## **CIRCLE COURT DRIVE SUBDIVISION, ADDITION**

Engineering Comments: FINAL PLAT COMMENTS (should be addressed prior to submitting the FINAL PLAT for review and/or signature by the City Engineer):

APPLICATION NUMBER 1 DATE June 6, 2019

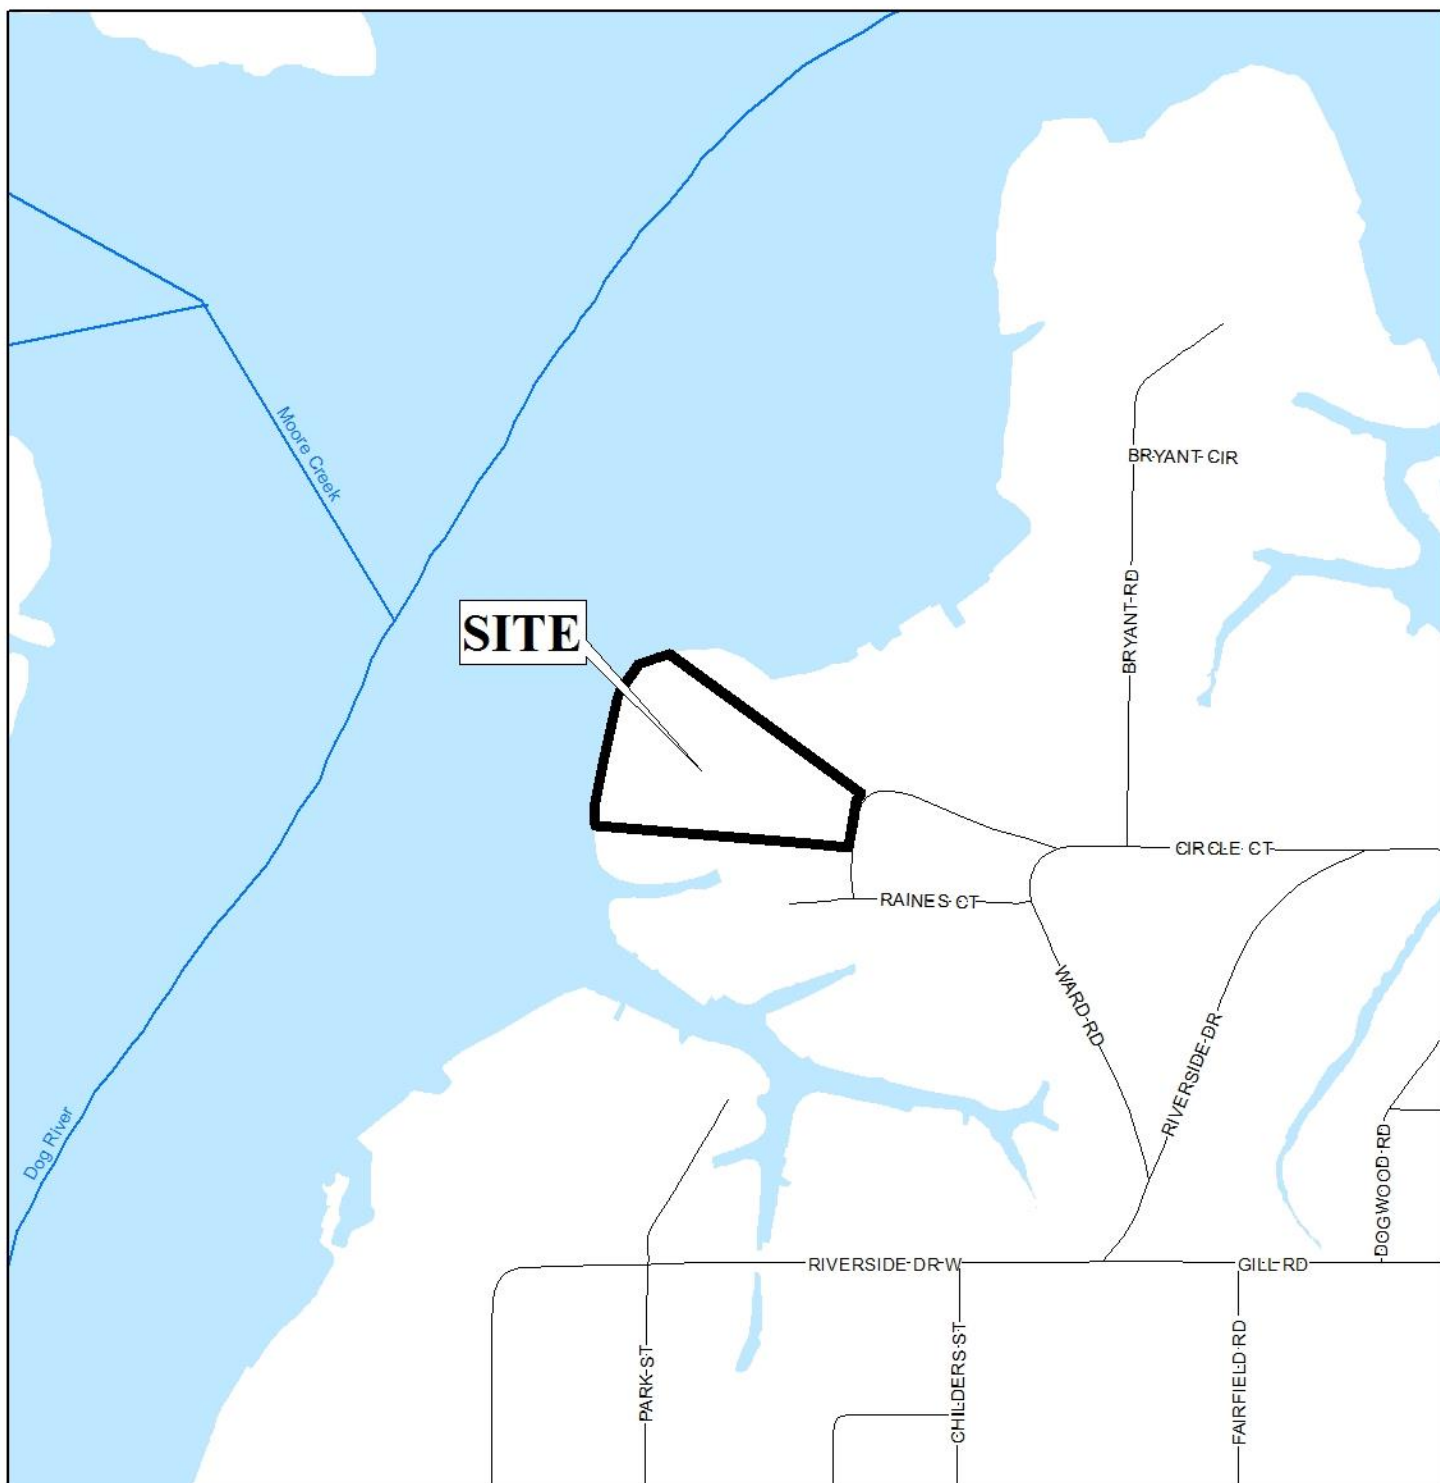
The site has frontage on Circle Court, a minor paved street. The preliminary plat indicates the right-of-way width of Circle Court to be 30'. However, as a minor paved street not provided with curb and gutter, a minimum 60' right-of-way is required per the Subdivision Regulations. As

such if approved, the Final Plat should be amended to show dedication to provide 30' from the center line along Circle Court. Furthermore, a June 1995 approved subdivision across Circle Court required the dedication of a portion of a cul-de-sac: this application should also provide its appropriate share.

As on the preliminary plat, the lot size label should be retained in both square feet and acres on the Final Plat, or a table should be furnished on the Final Plat providing the same information. No easements are indicated on the preliminary plat. If any easements are recorded on the site they should be indicated and labeled on the Final Plat, and a note should be placed on the Final Plat stating that no structure may be placed or constructed within any easement.

The plat illustrates a 25' minimum building setback for both lots, which should be retained on the Final Plat. If approved, the 25' setback should be retained on the Final Plat.

It should be noted that as proposed, both lots exceed the standards for width-to-depth ratio. Section V.D.3 of the Subdivision Regulations states that lot depth should not exceed 3.5 times the width of the lot at the building setback. As proposed, Lot 1 will be approximately 172' too deep, and Lot 2 will be approximately 456' too deep. Long, narrow lots are common on water frontage, therefore a waiver of Section V.D.3 may be appropriate.

Based on the preceding, this application is recommended for Tentative Approval, with a waiver of Section V.D.3 of the Subdivision Regulations, subject to the following conditions:

- 1) dedication to provide 30' from center line along Circle Court and an appropriate portion of the proposed cul-de-sac on the Final Plat;
- 2) retention of the 25' minimum building setback line along Circle Court, adjusted for dedication;

- 3) retention of the lot size in both square feet and acres, or the furnishing of a table on the Final Plat providing the same information, adjusted for dedication;

- 4) placement of a note on the Final Plat stating that no structure may be constructed or placed within any easement (if applicable);
- 5) compliance with the Engineering comments: *[FINAL PLAT COMMENTS (should be addressed prior to submitting the FINAL PLAT for review and/or signature by the City Engineer): A. Provide all of the required information on the SUBDIVISION PLAT (i.e. signature blocks, signatures, certification statements, written legal description, required notes, legend, scale, bearings and distances) that is required by the current Alabama State Board of Licensure for Professional Engineers and Land Surveyors. B. Provide a note that a 25' riparian buffer may be required, during development, along the edge of anything considered by ADEM to be a water of the state. C. Show and label all flood zones. The current FEMA map indicates areas of X (shaded). D. Show and label the MFFE (Minimum Finished Floor Elevation) on each lot that contains an AE, V, or X (shaded) flood zone designation. E. According to the preliminary 2019 FEMA map the AE and X (shaded) flood zone boundary is proposed to be revised to include additional*
